**COUNTY OF SAN MATEO  
PLANNING AND BUILDING DEPARTMENT**

**SUBJECT:** Non-conforming Use Permit (NCUP), Coastal Development Permit (CDP), and Design Review (DR) Permit, pursuant to Sections 6565.3, 6133.3 and 6328.4 of the Zoning Regulations, for the construction of a new, two-story, 1,828 sq. ft. single-family residence with an attached 367 sq. ft. one-car garage and attached 597 sq. ft. accessory dwelling unit (ADU) on a legal, non-conforming 3,986 sq. ft. parcel located at the intersection of Columbus Street and Sonora Avenue. The project involves only minor grading and no tree removal. This project is exempt from environmental review pursuant to the California Environmental Quality Act (CEQA) Guidelines, Section 15303, Class 3 (a), relating to the construction of one single-family residence in an urban, residential zone, and is appealable to the California Coastal Commission.

County File Number: PLN2023-00055 (Kellond)

1 FRONT ELEVATION  
COLUMBUS ST. (NORTHWEST)  
3/16"=1'-0"  
0 3' 6' 12'

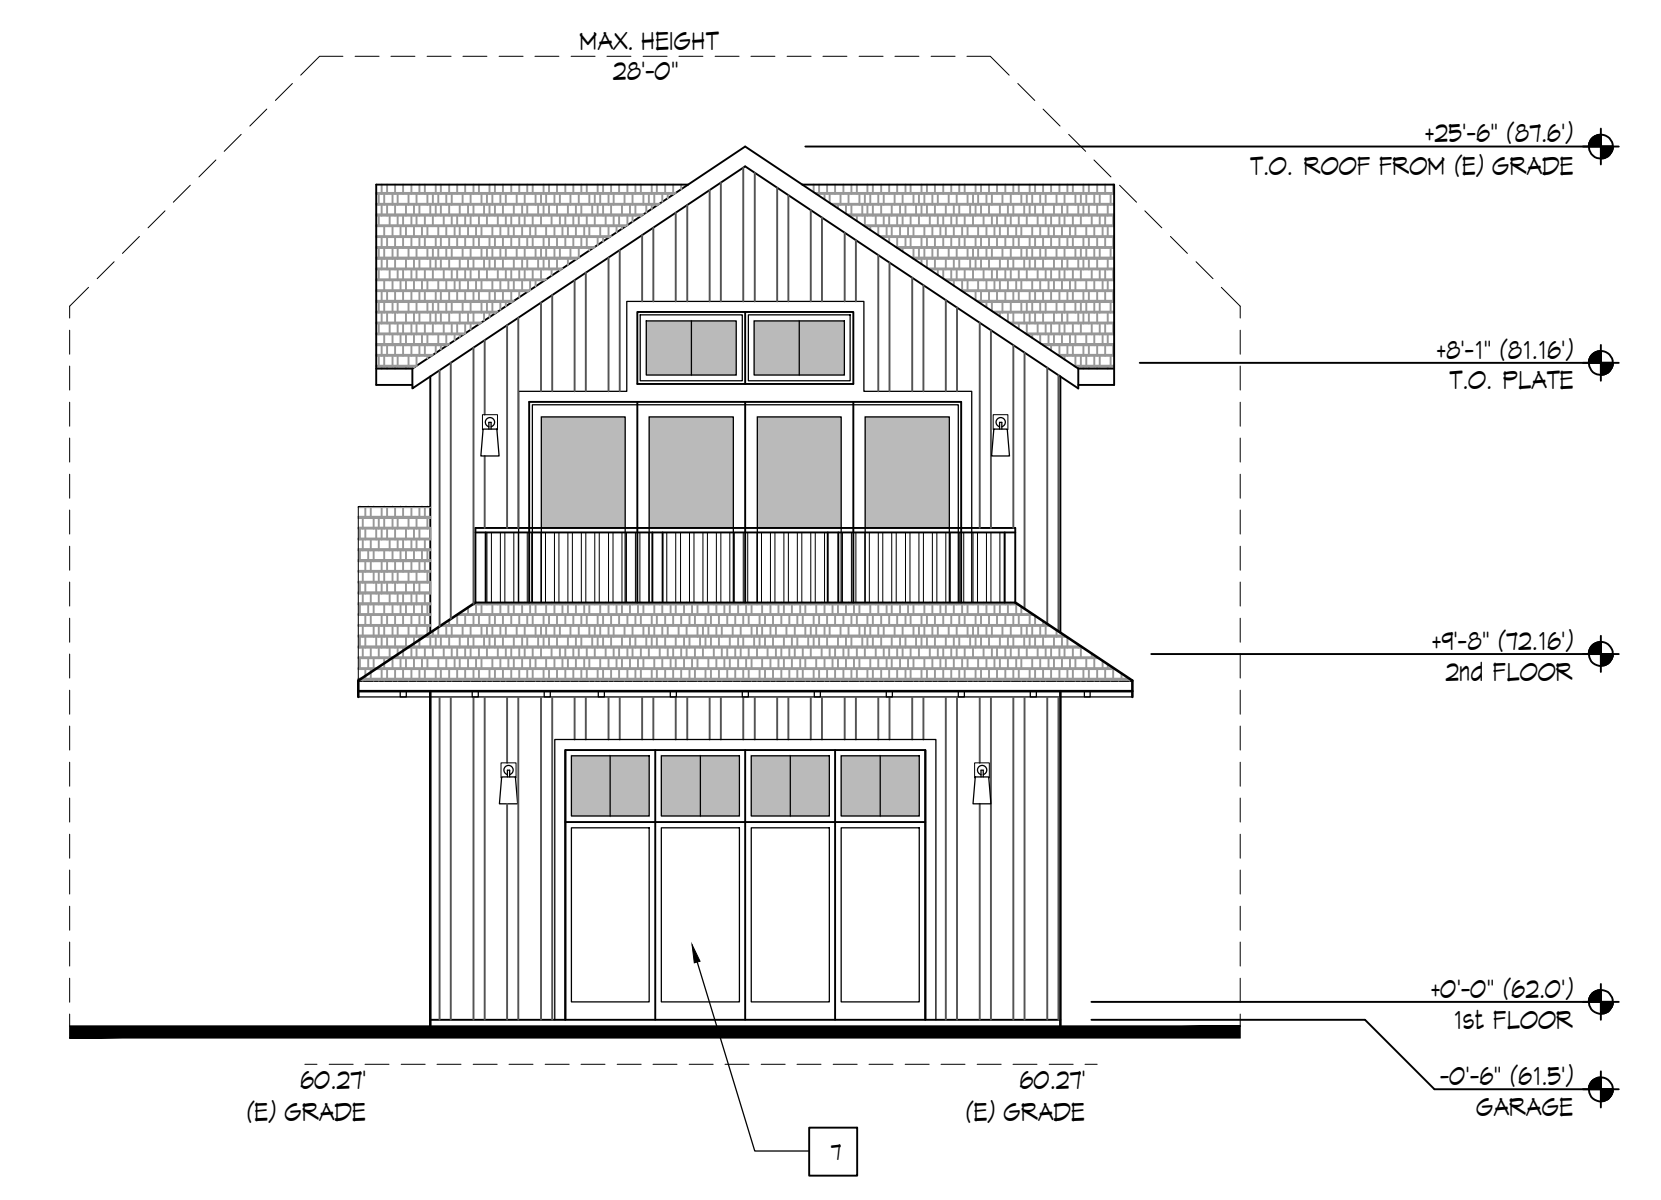
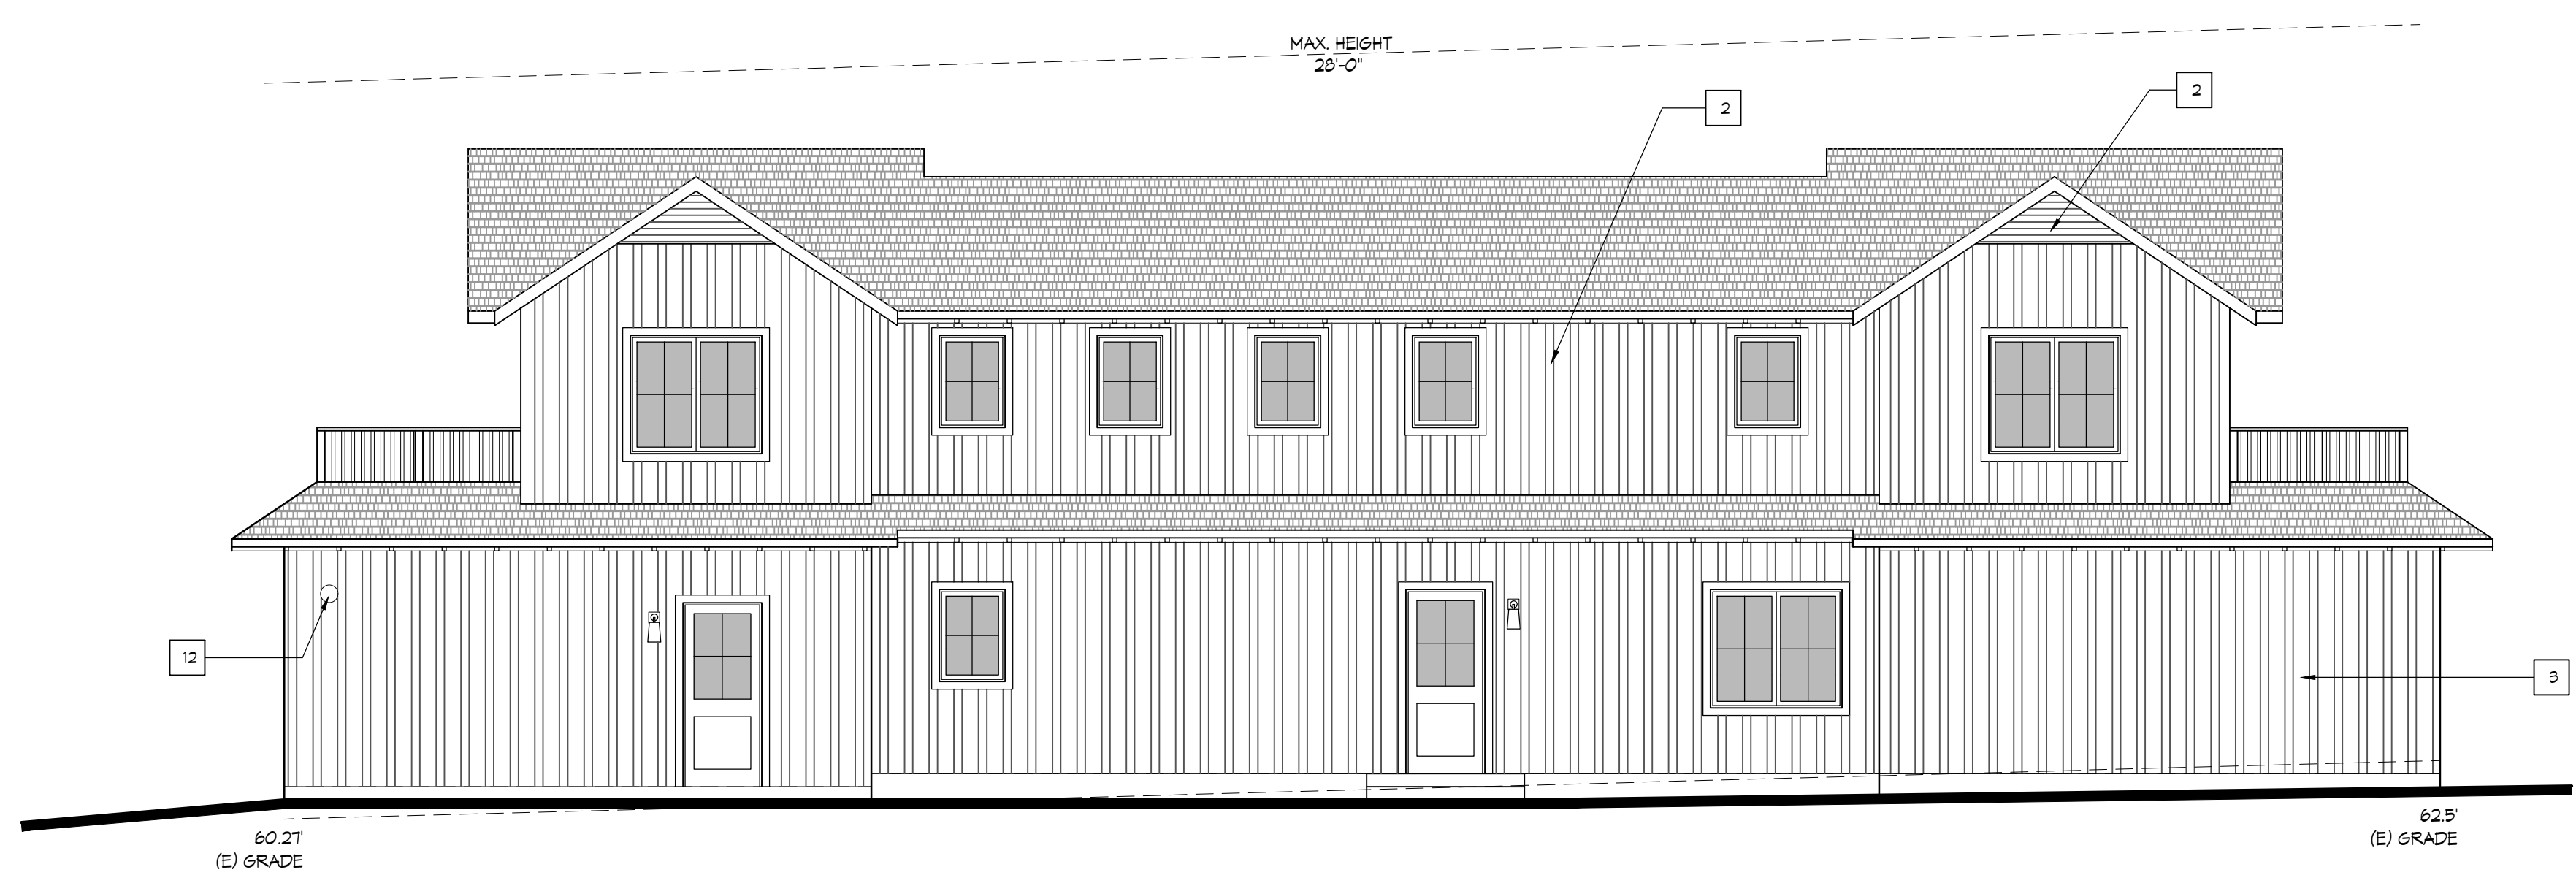
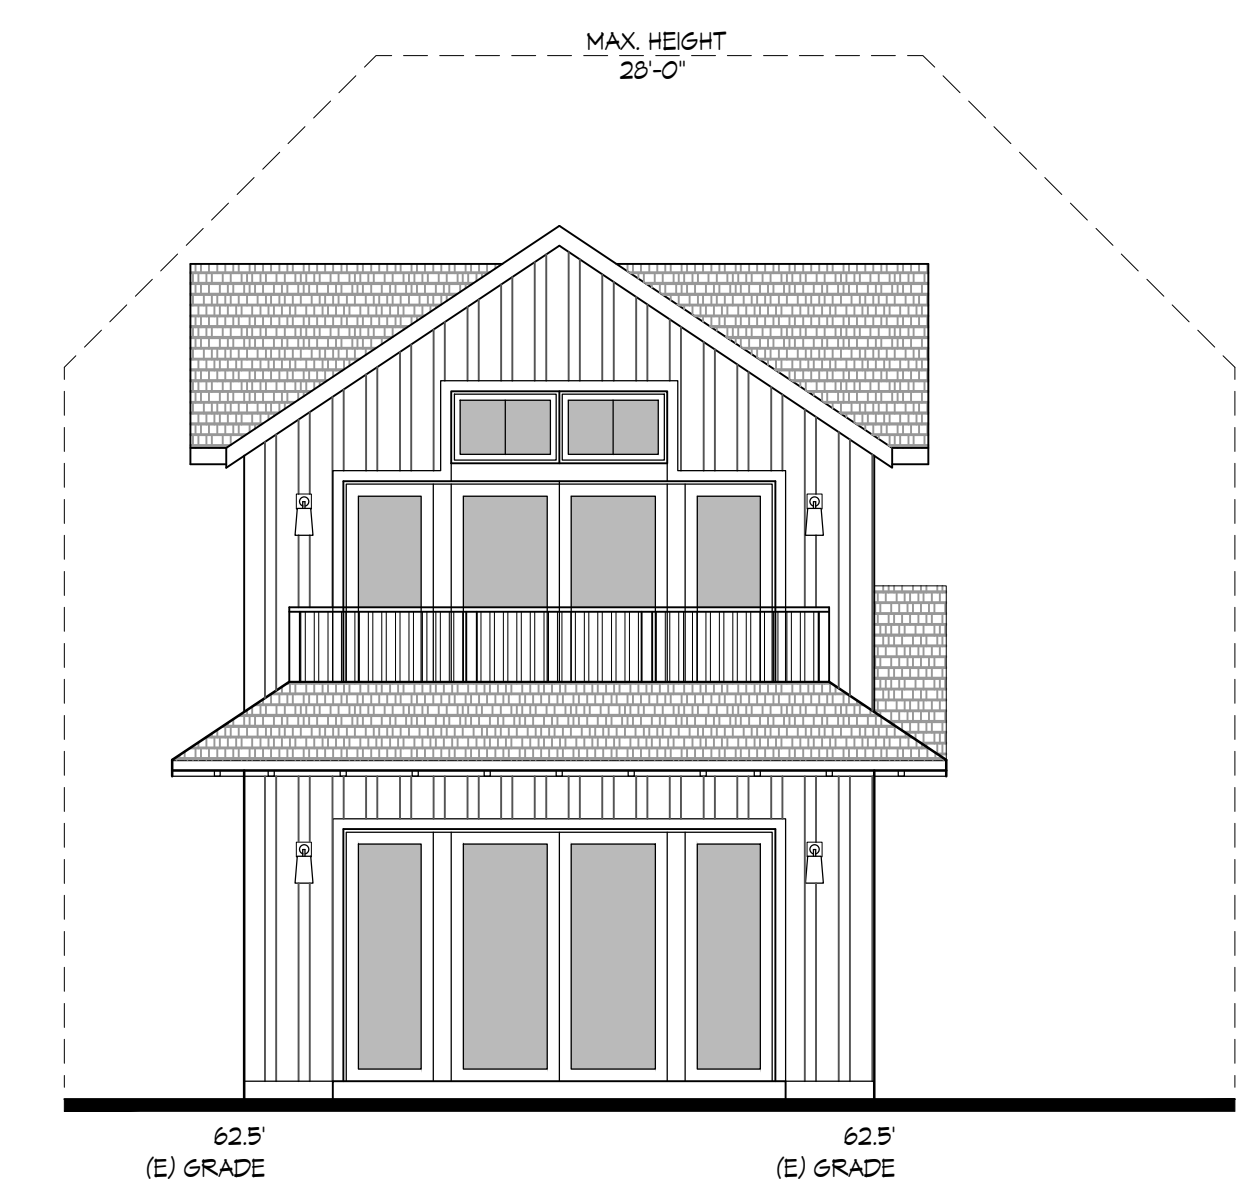
At the July 13, 2023, CDRC meeting, the committee asked for visual and ridge line articulation. The applicant changed the design to remove the request for setback variance and revised the ridge line to lower the house height by approximately 1-foot 6 inches. At the July 11, 2024, meeting, the CDRC reviewed the revised proposal and recommended approval of the project. The project, as proposed and conditioned, was found to be in compliance with the Design Review Standards for One-Family and Two-Family Residential Development in the Midcoast, Section 6565.20 of the San Mateo County Zoning Regulations, specifically elaborated as follows:

2. Section 6565.20(D)3a ELEMENTS OF DESIGN Roof Design, Massing and Design of Roof Forms: The mass of a roof and how it is articulated into different shapes contributes to the character of a house. **The revised project plans include additional articulation and forms to break up the apparent massing. The geometry of the lot dictates a narrow, but long structure.**

① FRONT ELEVATION  
COLUMBUS ST. (NORTHWEST)  
3/16"=1'-0"  
0 3' 6' 12'

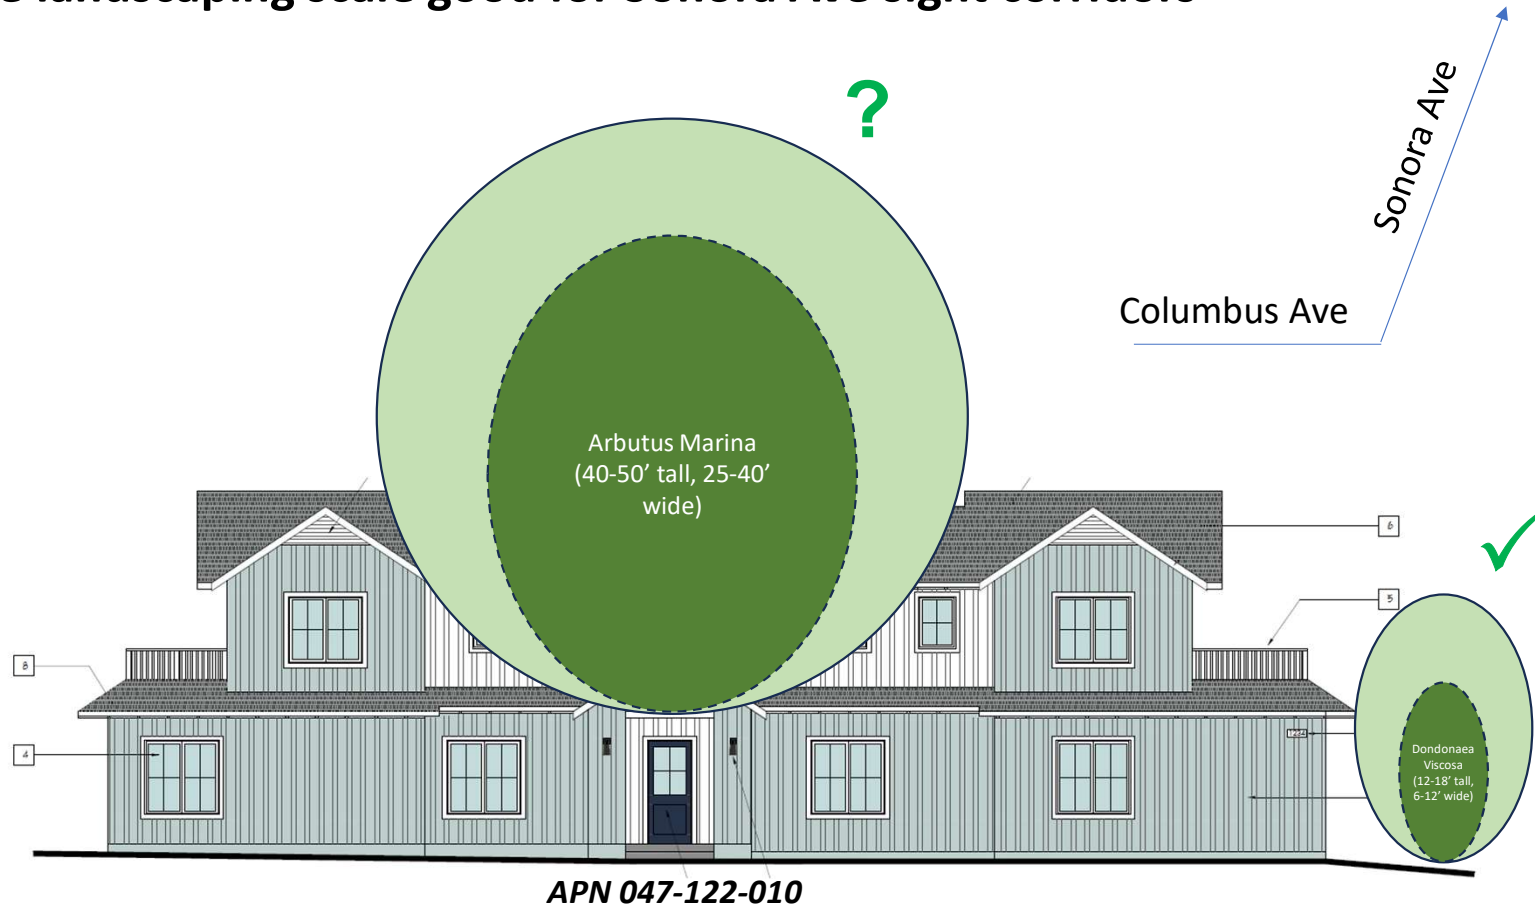
the effect on views from neighboring houses. Per attached public comment from “Suggestions for PLN2023-00055\_11July2024.pdf”, suggest change from gable to hip roofs on second story to reduce impact on views to neighboring property.

- a. The roof design could be changed from a gable to a hip roof to reduce the apparent massing of the house.
4. The applicant shall include a copy of the final approval letter on the top page of the building plans to provide the Planning approval date and required conditions of approval on the on-site plans.
